NDI ID PA-00945
PA DER 9-156

LAKE CAROLINE DAM

PHASE I INSPECTION REPORT.

FEBRUARY 1981

PROJECT Lake Caroline Dam, Field Observation Profile	SHEET 11B	BY R. R. B.	DATE 12/23/80	JOB NO. 1841-014
---------------------------------------------------------	--------------	----------------	------------------	---------------------

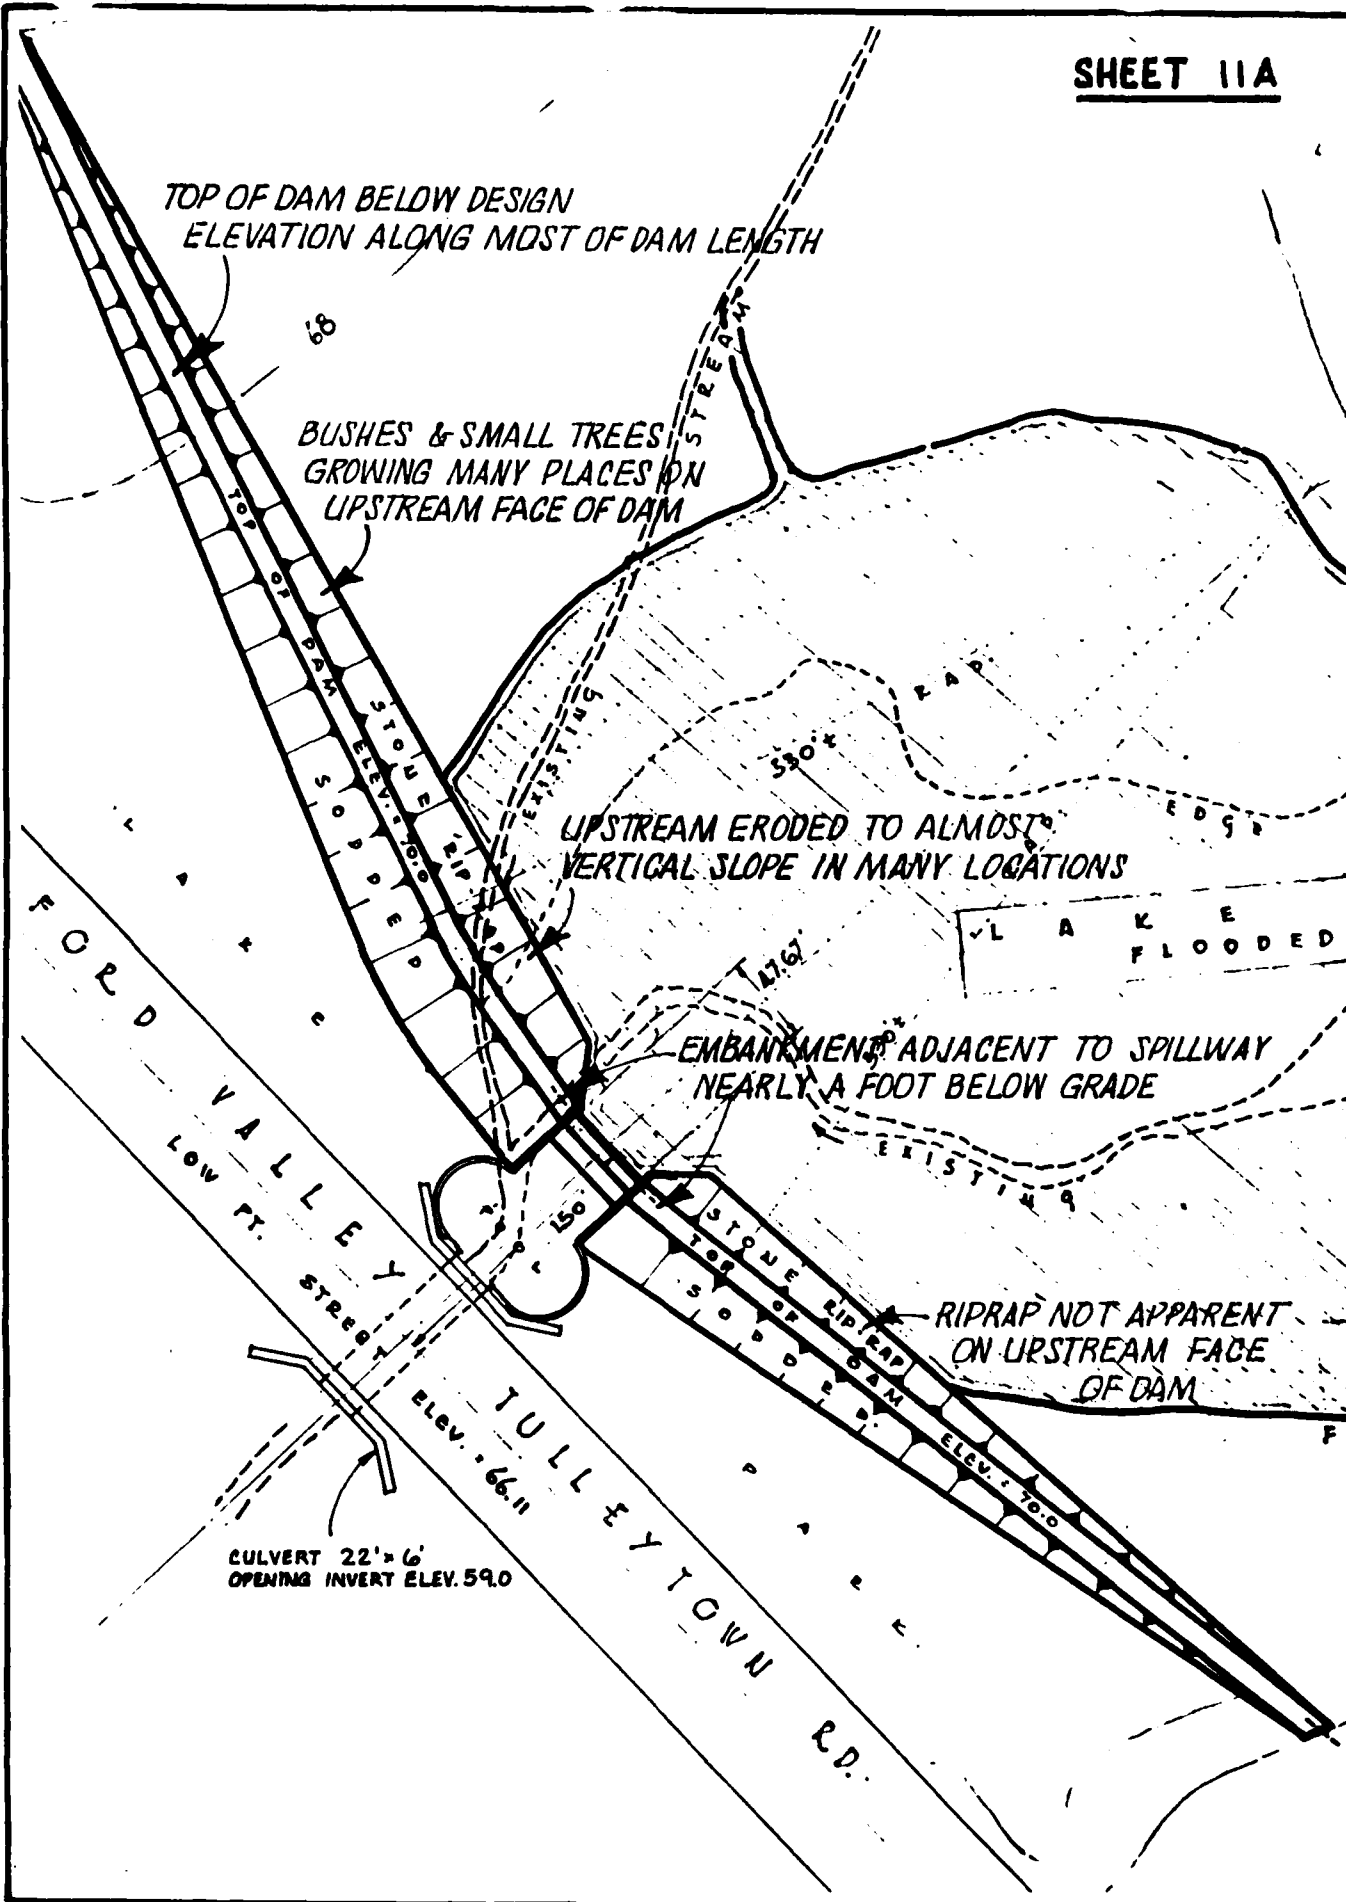
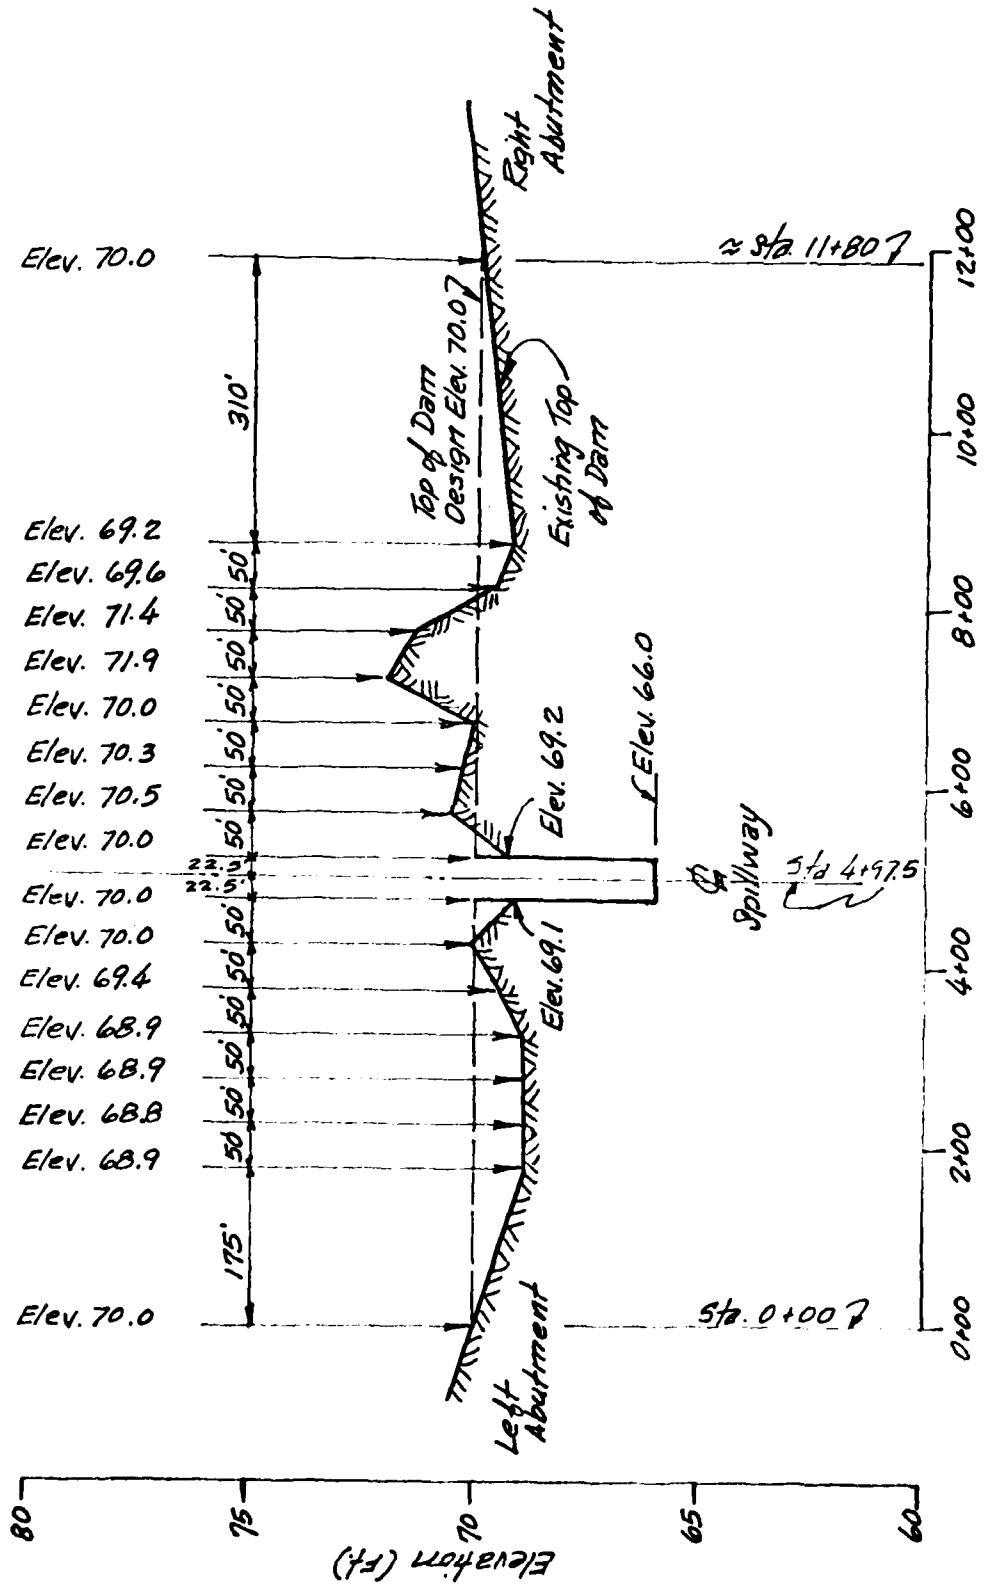
TOP OF DAM BELOW DESIGN
ELEVATION ALONG MOST OF DAM LENGTH

BUSHES & SMALL TREES
GROWING MANY PLACES ON
UPSTREAM FACE OF DAM

UPSTREAM ERODED TO ALMOST
VERTICAL SLOPE IN MANY LOCATIONS

EMBANKMENT ADJACENT TO SPILLWAY
NEARLY A FOOT BELOW GRADE

RIPRAP NOT APPARENT
ON UPSTREAM FACE
OF DAM
